Application Serial No. 10/734,753      Response to Office Action mailed Sep. 7, 2005

**AMENDMENTS TO THE DRAWINGS:**

Application No. 10/734,753  
 Amendment Dated December 1, 2005  
 Reply to Office Action of September 7, 2005  
 Annotated Sheet Showing Changes

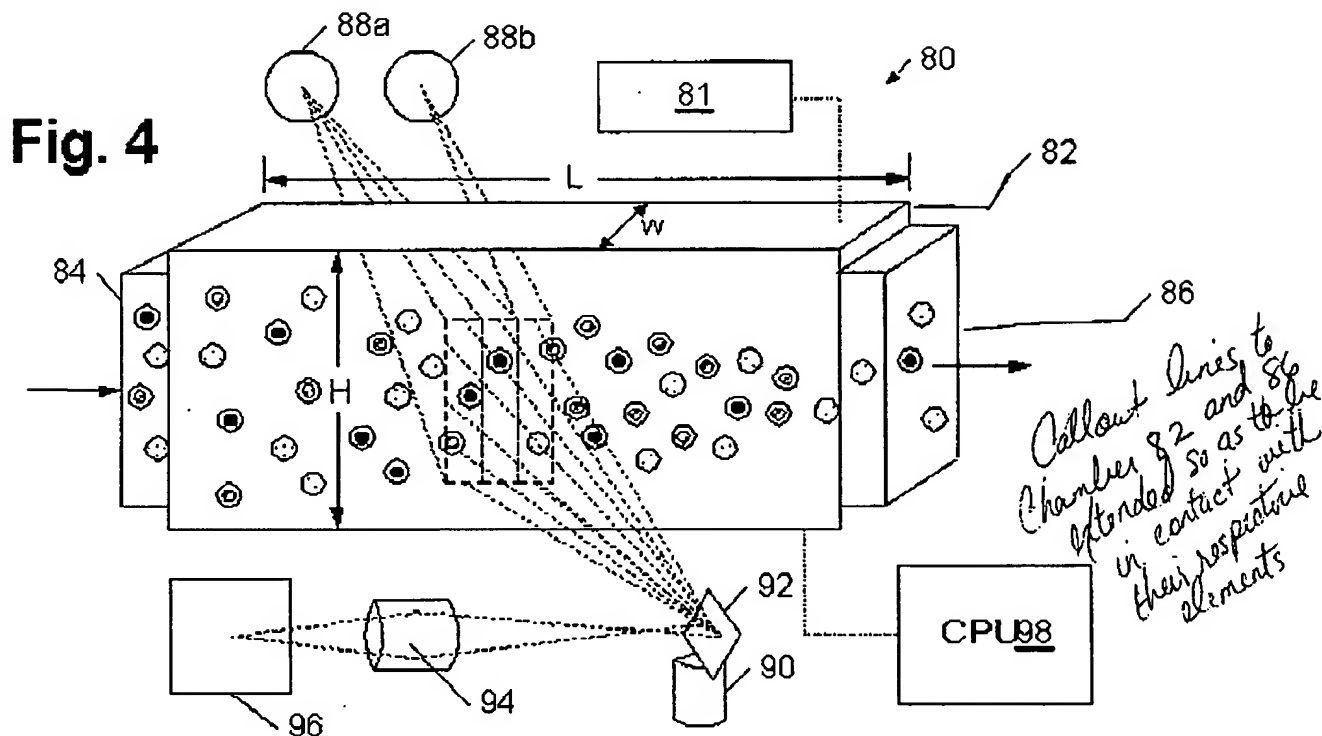
The attached sheet of drawings includes changes to FIG. 4. This sheet, which includes FIGS. 4-5, replaces the original sheet comprising FIGS. 4-5. The call out lines to chamber 82 and outlet 86 have been extended so as to be in contact with their respective elements.

In this Response, the Applicant has amended the Specification at paragraphs [0004], [0007], [0010], [0014], and [0015] to correct minor typographical errors. The Applicant amended FIG. 4 to clarify the call out lines to elements 82 and 86. The Applicant has amended claim 1 to incorporate the limitation of dependent claim 3 and has amended claim 10 to include the limitation of "fluid moving at laminar flow". No new matter within the prohibition of 35 U.S.C. § 132 has been added. The Applicant kindly requests reconsideration and allowance of the pending claims for the reasons detailed below.
